ITS DISCUSSION OF DIFFERENCES

ITS Section 3.3B: Instrumentation - ESAS

Note: The ITS Section 3.3B package addresses the following NUREG-1430 LCOs:

Table 3.3.11-1

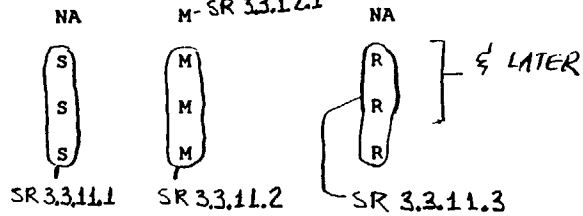
- a. Manual
- # 1. b b. SG Low Level, SGA or B
- # 1. C c. Low Pressure SGA or B
- # 1. D d. Loss of both MFW Pumps and PWR > 10%
